STRATEGIC PETROLEUM RESERVE

ENGINEERING CHANGE PROPOSAL
SUMMARY SHEET
CLASS I CHANGE

ECP NUMBER	TITLE
SJ-M/O-4618	Sugarland Expansion 36-Inch Tie-In Line

ECP NUMBER	ECP TITLE	
SJ-M/O-4618	Sugarland Expansion 36-Inch Tie-in Line	PAGE 1 OF 1

SUGARLAND TO EXPANSION FACILITY
36" TIE-LINE (Overview)

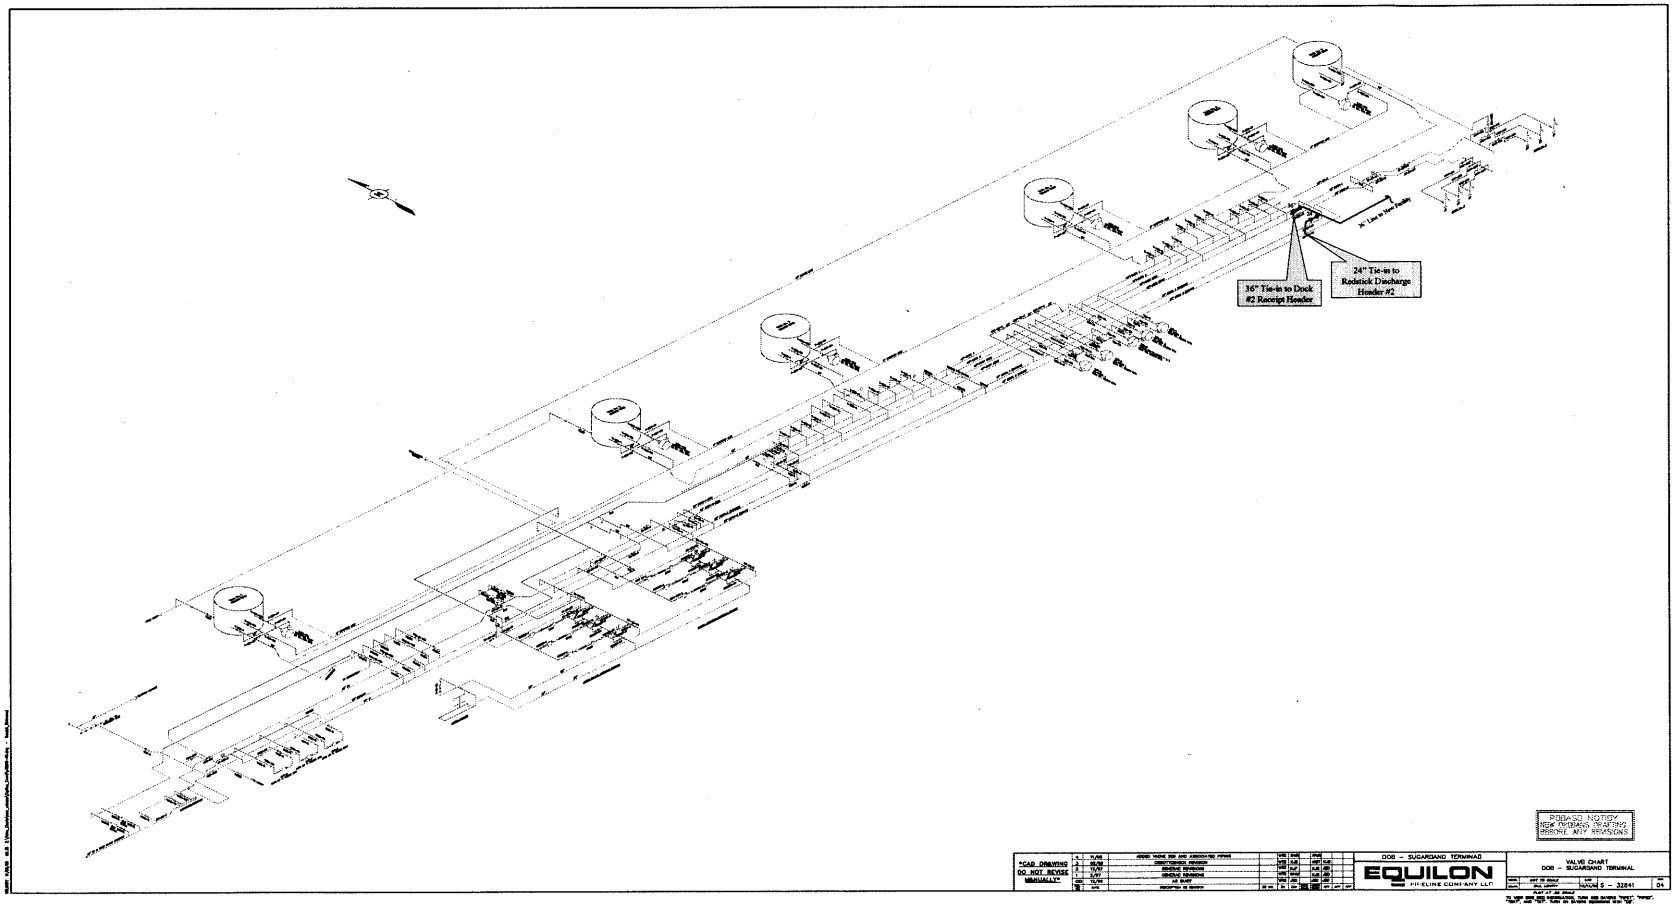
PROPOSED SOLUTION / ENHANCEMENT **Build a new 36" pipeline from the new facility to a new header at Sugarland Terminal which will be located near the incoming dock 1 & 2 lines. The header would tie-into the 36-inch Redstick Discharge 2 line with a 24-inch valve, and the Dock #2 Receipt header line with a 36-inch valve. Accommodations would be made in the new header for future connections to the other suction, discharge and dock lines in order to provide further flexibility, if warranted. See attached drawings for detail of the proposed solution.** PROVISIONS TO "BLIND" PIPING ON THE ST. JAMES TERMINAL PROPERTY WILL BE PROVIDED. [illegible] 6/1/01

SUGARLAND EXPANSION
ACADIAN RIVER TERMINAL
S-J-W/O-461B

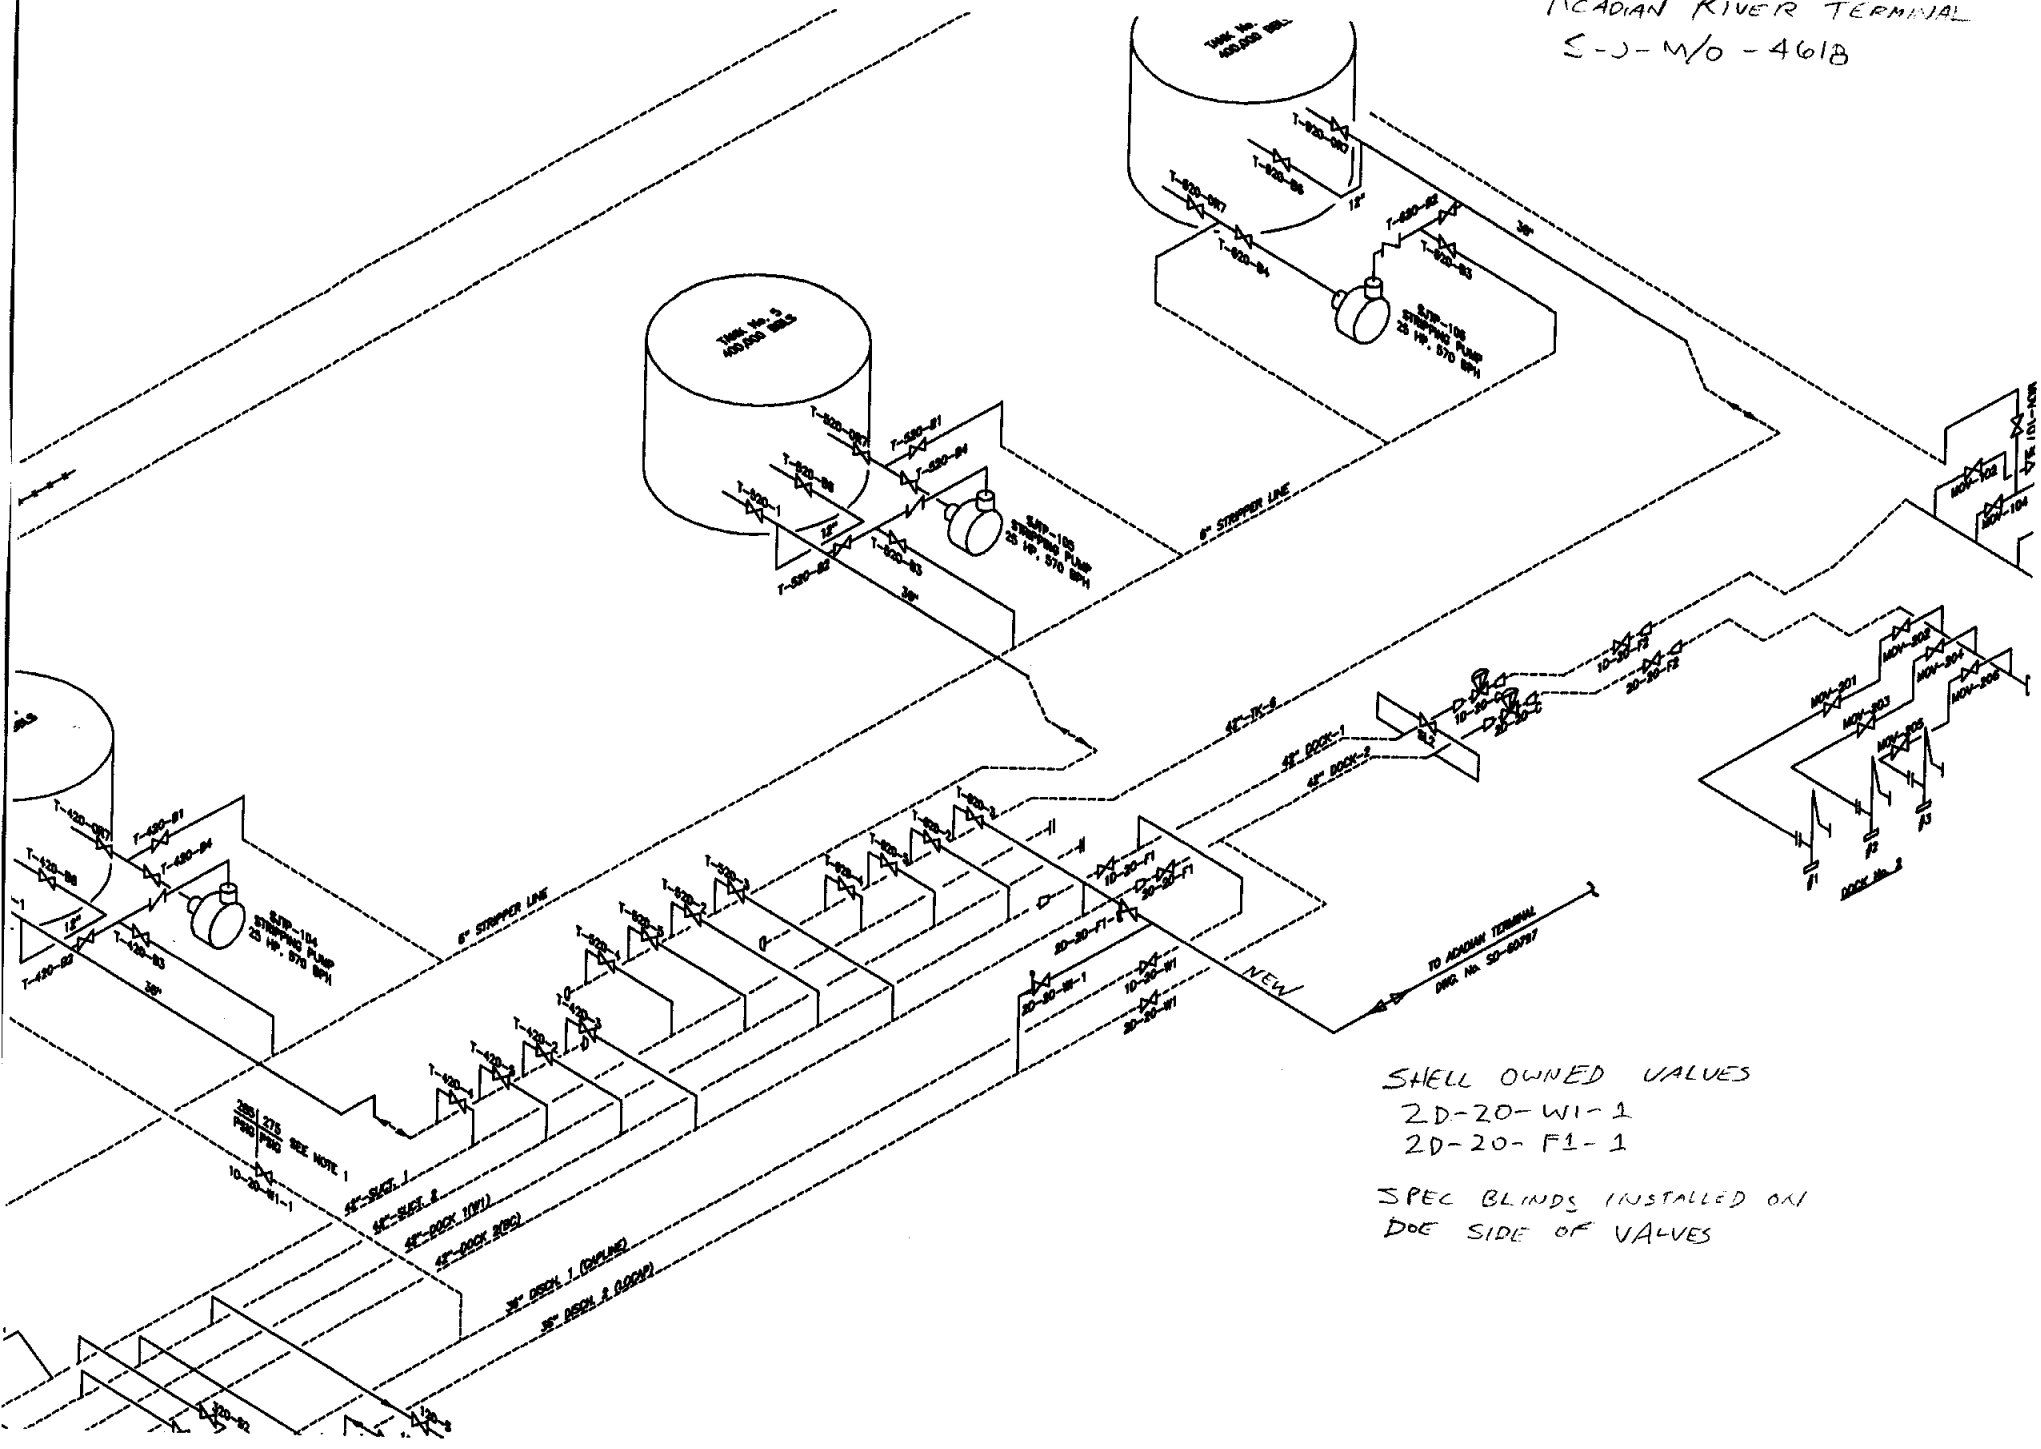
SJ – M/O – 4618 Sugarland Expansion (Acadian River Terminal)
The first sketch is a detail of the valve chart that shows where the new valves were installed. The following four sheets are 8-1/2 X 11 details of the pipe routing through the tank yard.

SHELL OWNED VALVES
2D-20-W1-1
2D-20-F1-1

SPEC BLINDS INSTALLED ON
DOE SIDE OF VALVES
